**RE: Tentative Waste Discharge Requirements (WDRs)  
Kern County Public Works Department Comments  
McFarland-Delano Sanitary Landfill  
Kern County, California  
WDID No. 5D150303010**

# McFarland-Delano Landfill – Tentative Waste Discharge Requirements (WDRs)

## Kern County Public Works Department (KCPWD) Summary of Comments

### Comment #1 WDR: Public Hearing (pdf page 3)

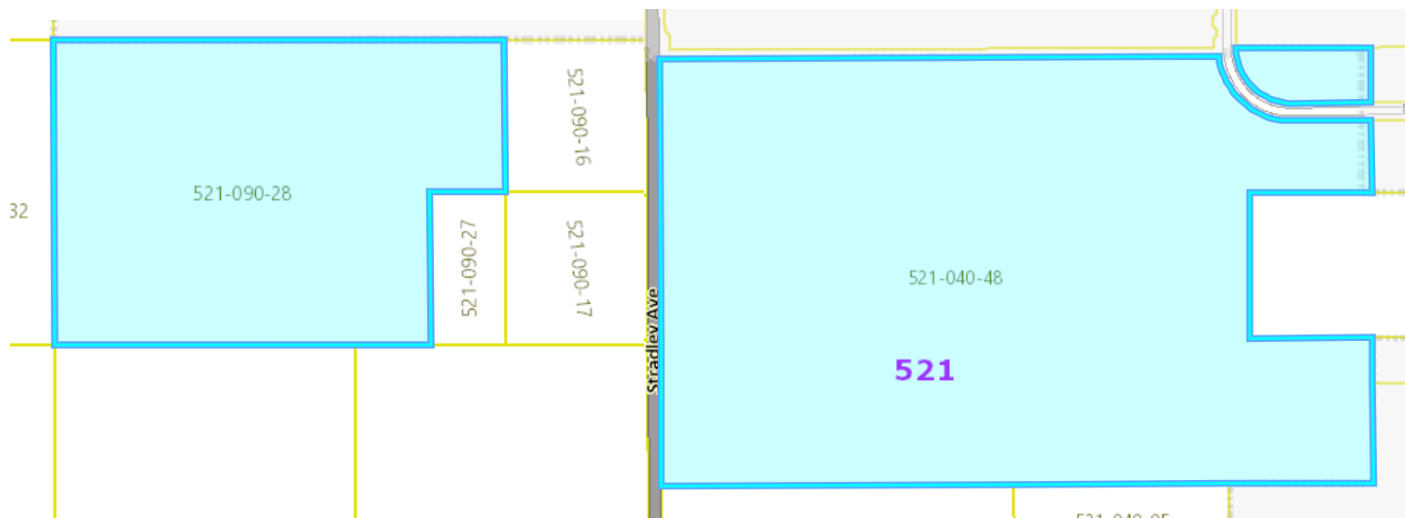
The approximate acreage of the facility is 136 acres. (from KC GIS)
